Technical Service Information

THM 4T80-E

NEW DESIGN CENTER SUPPORT AND GASKET

Figure 1

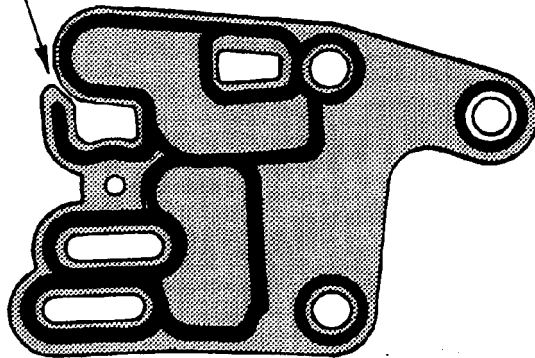
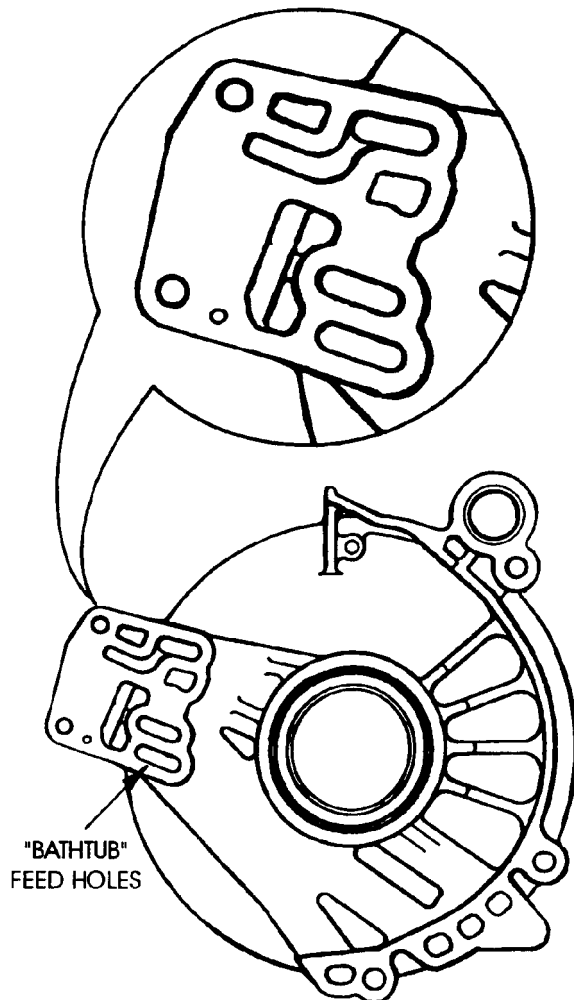
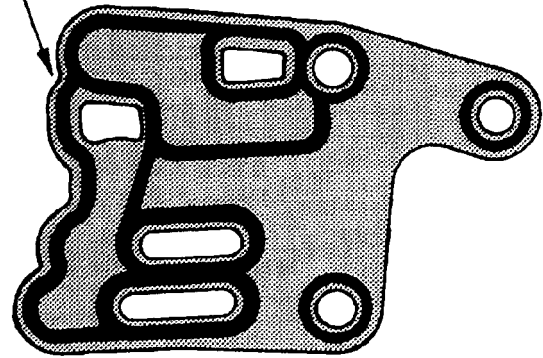
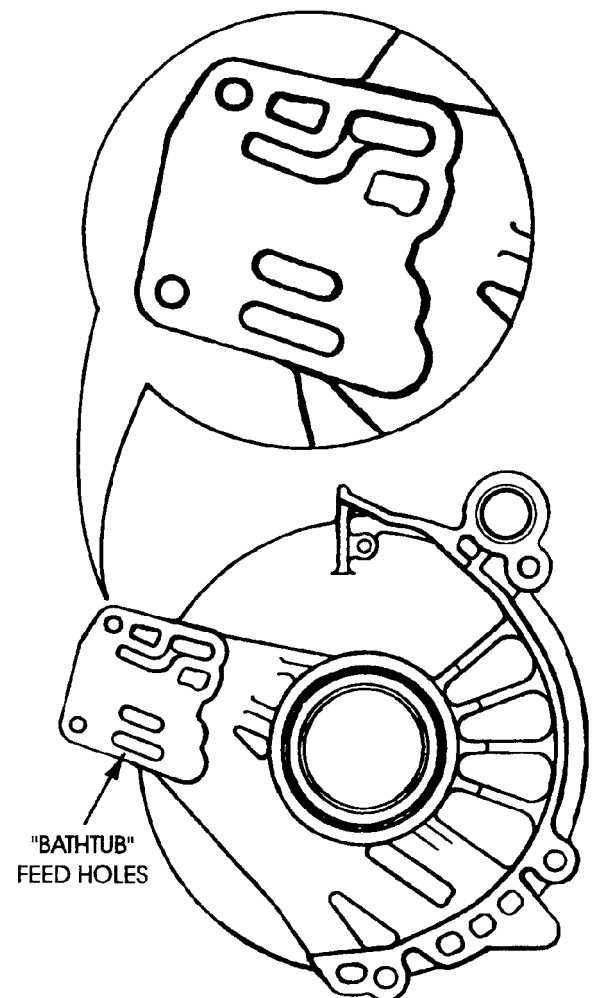
CHANGE: Beginning at the Start Of Production for 1995 models, all THM 4T80-E transaxles were produced with a new design level Driven Sprocket Support and center gasket (See Figure 1). This allowed the use of four 2nd clutch plates, instead of the previous three.

(1) DRIVEN SPROCKET SUPPORT - New design level to accommodate 4 second clutch plates instead of the previous 3 second clutch plates. This required moving the two “Bathtub” feed holes in the Driven Sprocket Support (See Figure 1).

(2) SPROCKET SUPPORT GASKET - The two “Bathtub” feed holes in the gasket were moved to accommodate the new design sprocket support. The slot in the gasket was also removed on the new design gasket (See Figure 1).

The Driven Sprocket Support Gaskets “WILL NOT” interchange. The 93-94 gasket must be used with the 93-94 sprocket support, and the 95-96 gasket must be used with the 95-96 sprocket support (See Figure 1).

Driven Sprocket Support Gasket (93-94 Model Only)	8683 149
Driven Sprocket Support Gasket (95-96 Model Only)	2420 1535
